PLANNING BOARD APPLICATION

Re: Preliminary and Final Site Plan Review No. 1
Applicant: The Peddie School
Development: Athletic Center Solar
Block 53, Lot 1.02
Borough of Hightstown, Mercer County, New Jersey
Our File No.: HPB202202

Re: Preliminary and Final Site Plan Review No. 1
Applicant: The Peddie School
Development: Athletic Center Solar
Block 53, Lot 1.02
Borough of Hightstown, Mercer County, New Jersey
Our File No.: HPB202202

LIGHTING PLAN

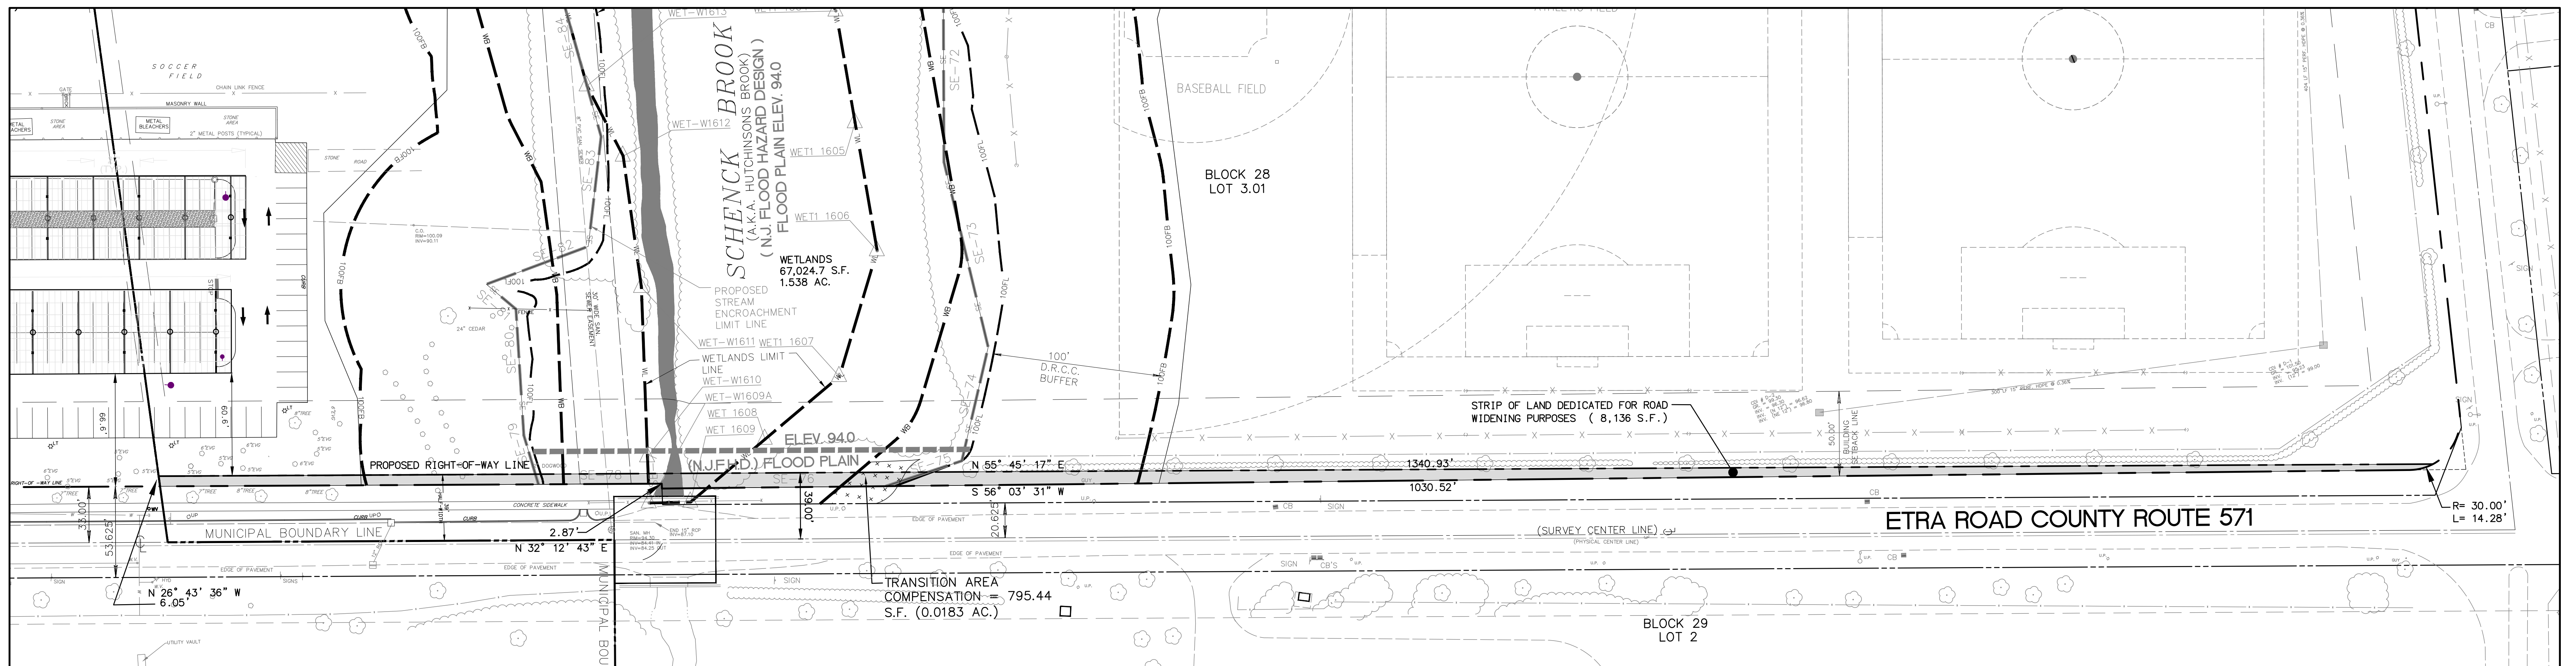
- d. The point-by-point lighting analysis indicates light intensities ranging from 0-foot candles by the Etra Road sidewalk to a high of 4.1-foot candles under the canopy lighting, as shown on Sheet 8, Lighting Plan.

- f. Please provide a full lighting analysis of the parking lot for all the lighting. The lighting intensity for the canopy lights is extremely high and appears will have a negative impact on the surrounding area.

- g. Confirm the need for such bright lighting or reduce the lighting levels to current light levels in the parking lot.
- h. Provide a detail of the proposed light along with its placement under the solar canopy.
- i. It is recommended that the lights be motion activated and/or have dusk to dawn controls.
- j. The plans should identify all fixtures that will be used for security lighting with a notation added to the plan, indicating the shut off time for the remaining site lighting.
